**LOT 2 COCHRANE ROAD, CADOUX, WA, 6466
APPROVED UPGRADES & ADDITIONS TO CBH'S EXISTING GRAIN HANDLING &
STORAGE FACILITY IN CADOUX (A1600/P490)**

In relation to Council Resolution 100322 from the Council Meeting held on 23 March 2022, please find below CBH's response to conditions 4 and 6.

Project:	Cadoux Site Expansion: Stormwater Management Plan
Client:	CBH
Author:	R. Needham
Date:	2 nd May 2022
Shawmac Document #:	2006010-REP-003
CBH Document #:	370-2915-CI-RPT-0001

Figure 2: Site Exit at Cochrane Rd & King St intersection – Estimated Area of Seal Defects

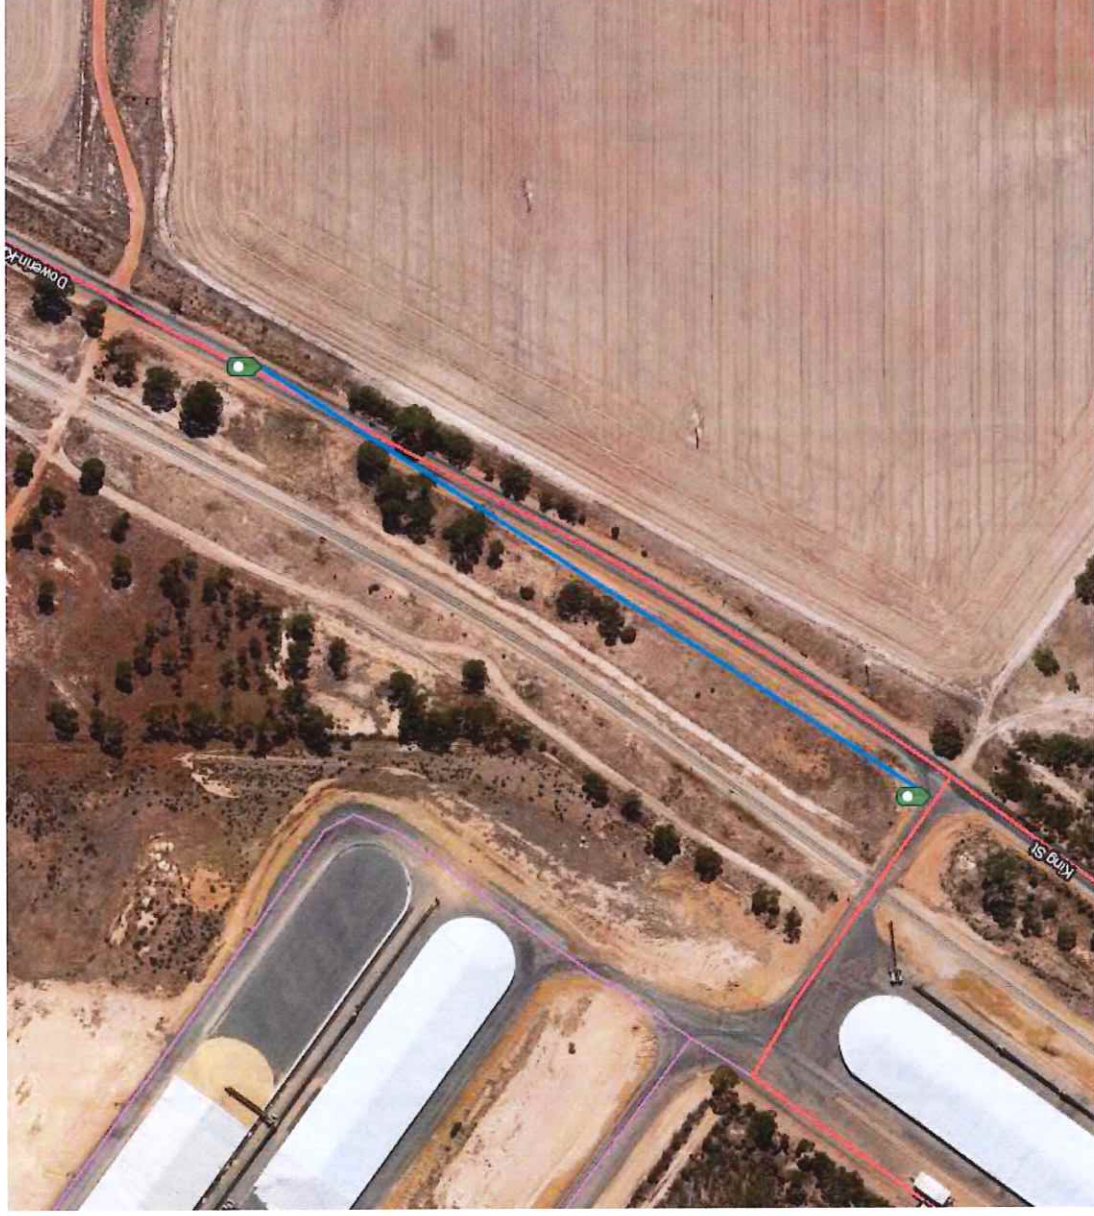
2.2 - Rough Road Surface (see Figure 1 below for location)	Repair pavement defects – flushing/bleeding seal and potentially deteriorated pavements.	See Figure 2 below Profile 50mm and reseal & asphalt (Intersection Mix) the Site Exit at the Cochrane Rd & King St intersection, estimated 623m ²	<p>Shawmac: Extent of defects needs to be confirmed on site</p> <p>CBH: Agrees with Shawmac’s comments and will consider 50/50 split on cost of these works if extent of the defects do not surpass 50m in any direction from the Site Entry and Site Exit. Shire executes and manages the works and Contractor. Shire also to be responsible for any regulatory approvals required.</p>

Figure 3: Site Exit at Cochrane Rd & King St intersection – Required Line of Sight: 300 metres north.

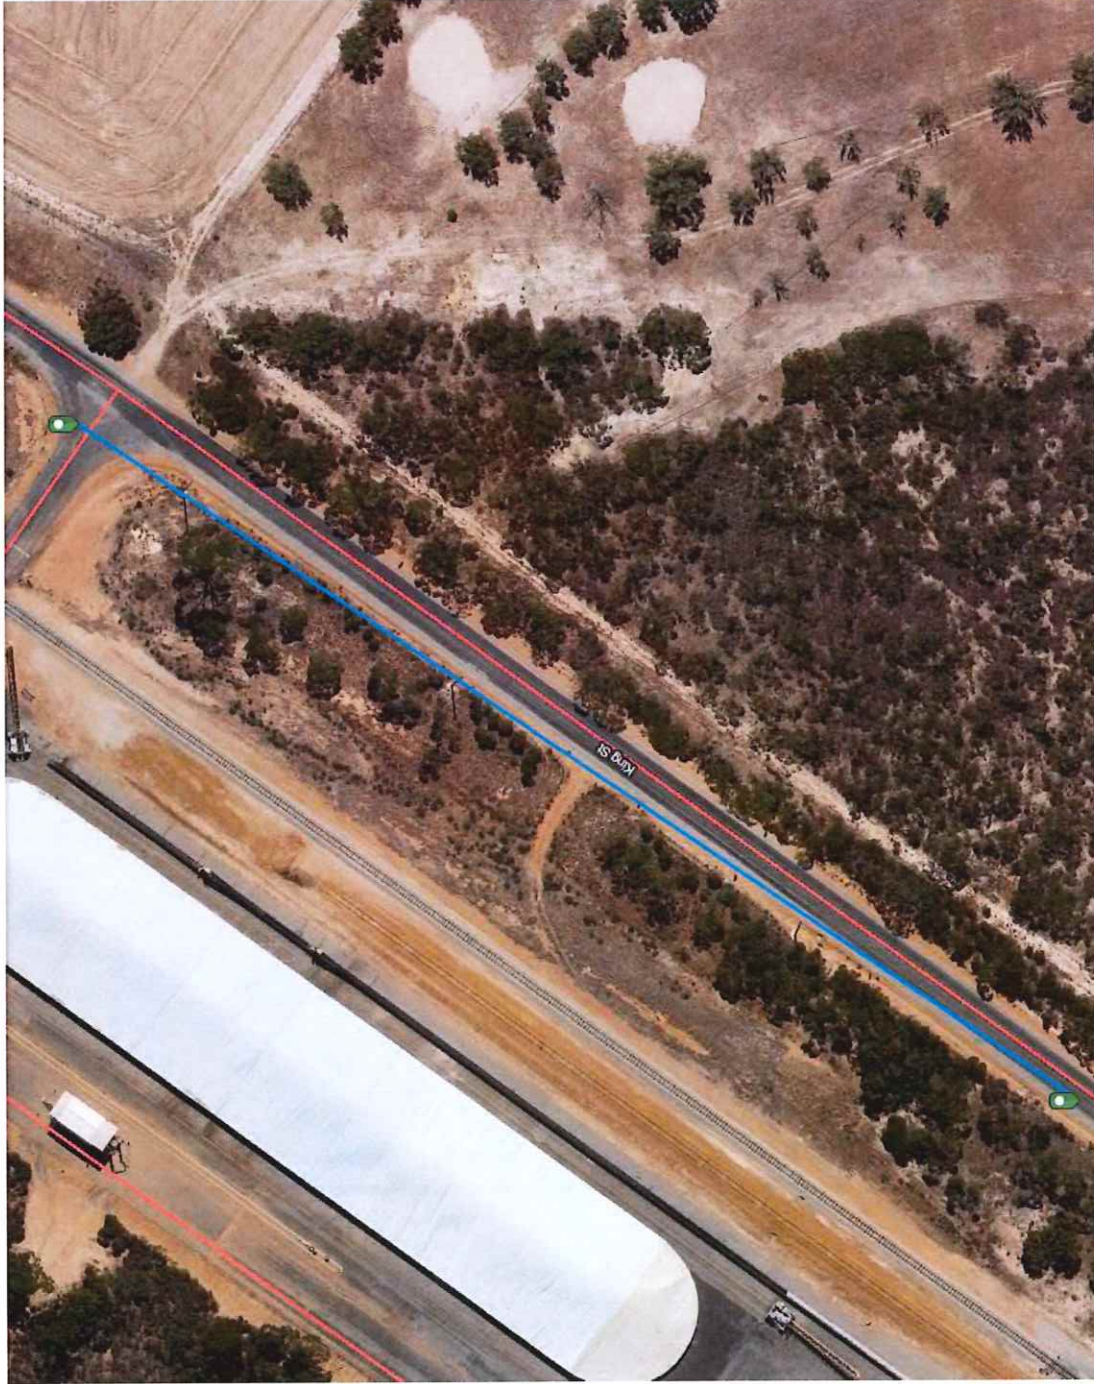
RSA Finding	Works Required	Quantities	Comments
2.3 - Sight Distance (Vegetation) (see Figure 1 below for location)	TBC on site - likely trimming of vegetation only	TBC	<p>Shawmac: Sight line sketches are provided below in Figures 2 & 3 (300m required to the north, 256m to the south). The sight lines do clip the vegetation based on an aerial view available to us, but it may not be an issue on site (to be confirmed on site). Trimming acceptable as long as a clear line of sight is provided.</p> <p>Coordinates are: Eye location – 117.139, -30.765 To south – 117.137, -30.767 To north – 117.141, -30.763</p> <p>CBH: CBH will peg out the coordinates. A site assessment on the line-of-sight will be required with a Shire Representative. Best case, only “tree trimming” activities are required to provide the line of sight. Shire executes and manages the works and Contractor. Shire also to be responsible for any regulatory approvals required.</p>

Figure 1: Location of Findings

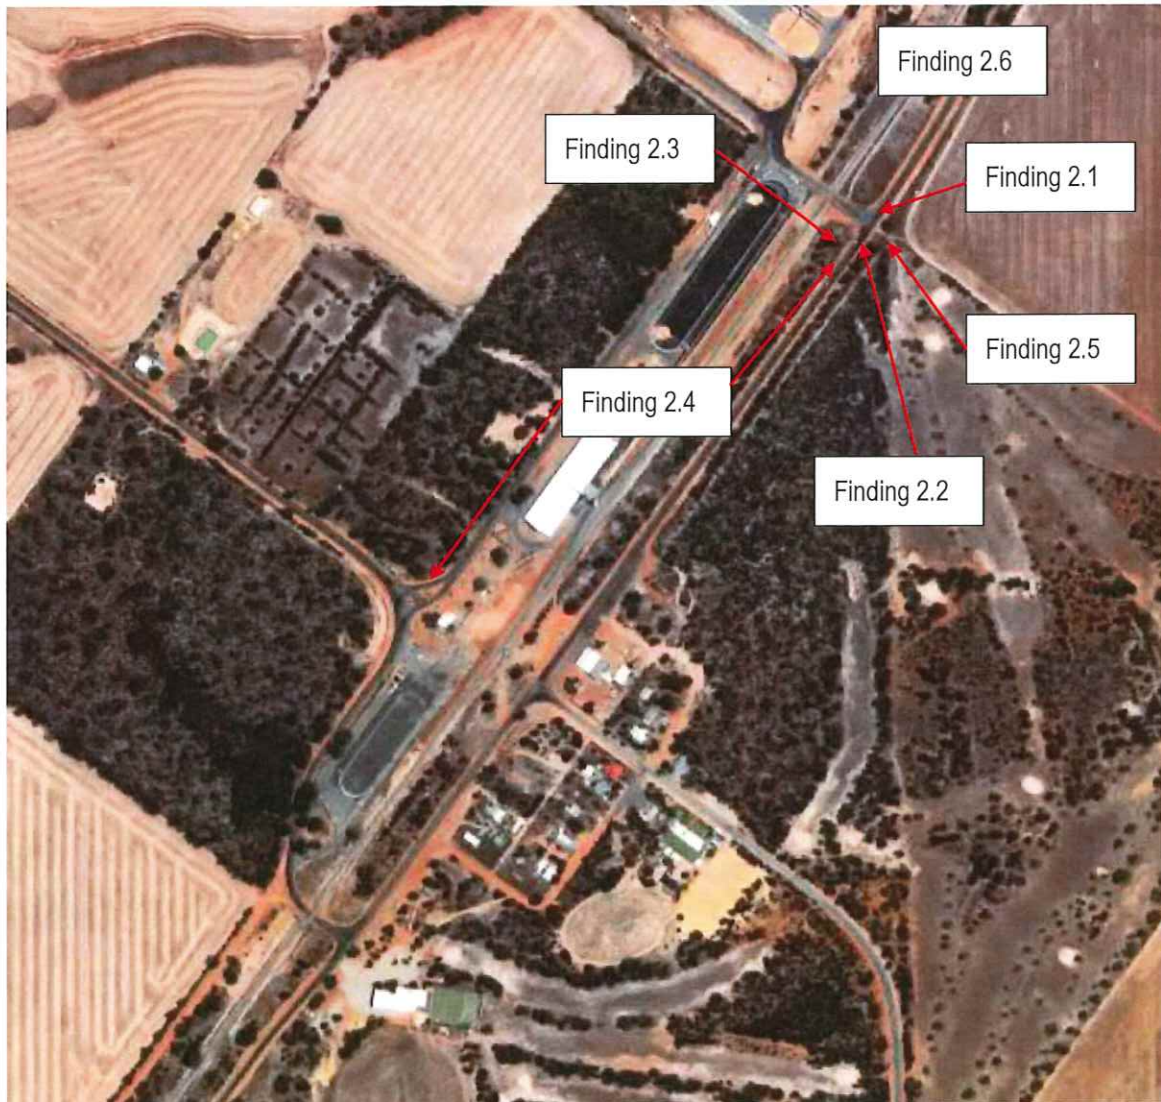
RSA Finding	Works Required	Quantities	Comments
2.1 - Unprotected Culvert (see Figure 1 below for location)	Culvert headwall on north bound lane of King Street is approx. 1.5m from edge of seal. South bound lane headwall is approx. 2.0m from edge of seal. Clear zone required for 110km/h is 8m. Extend north bound culvert by 6.5m, south bound by 6m, backfill and compact. Existing headwalls can be retained if in suitable condition.	12.5m total culvert extension length, provision for 2x headwall replacements, allow 30m ³ sand for bedding and backfill.	<p>Shawmac: Existing culvert dia. is unknown – need to confirm with Shire on-site.</p> <p>CBH: Agrees with Shawmac’s comments and will consider 50/50 split on cost of these works; Shire to execute and manage the works and contractor. Shire also to be responsible for any regulatory approvals required.</p>

2.4 - Pavement Marking and Signage (see Figure 1 below for location)	N/A	N/A	<p>Shawmac: Pavement marking and signage at the Cochrane Road and King Street intersection is not required in accordance with AS1742.2 given this is a tee intersection and the priorities are clear. Recommended that “trucks entering” warning signage is applied to the major road, however in accordance with AS1742.2 this could be temporary signage during harvest periods.</p> <p>CBH: Permanent solution required at the Cochrane Road and King Street intersection as well as the Cochrane Road and Wongan Hills-Cadoux Road intersection as trucks enter and exit the site during most parts of the year for out-loading activities, not just harvest periods (in-loading). CBH willing to bear 50% of the cost of these works. Shire executes and manages the works</p>

RSA Finding	Works Required	Quantities	Comments
			and Contractor. Shire also to be responsible for any regulatory approvals required.
2.5 - Terminating Road Signage (see Figure 1 below for location)	N/A	N/A	<p>Shawmac: Not required - As per AS 1742.2, a sight board would only be required at the Cochrane Road and King Street intersection if approach speeds on terminating leg are high which is not the case for vehicles exiting the CBH site.</p> <p>CBH: Agrees with Shawmac's comments i.e. the signage not required upon engineering review.</p>

2.6 - Speed Limit Change to 70km/h (see Figure 1 below for location)	N/A	N/A	<p>Shawmac: Understood MRWA is not supportive of this. Consideration could be provided to implementing a temporary reduced speed zone during harvest periods under a Traffic Management Plan.</p> <p>CBH: CBH happy for Shire to consult MRWA (if required) for approval of temporary speed limit change during harvest periods only.</p>
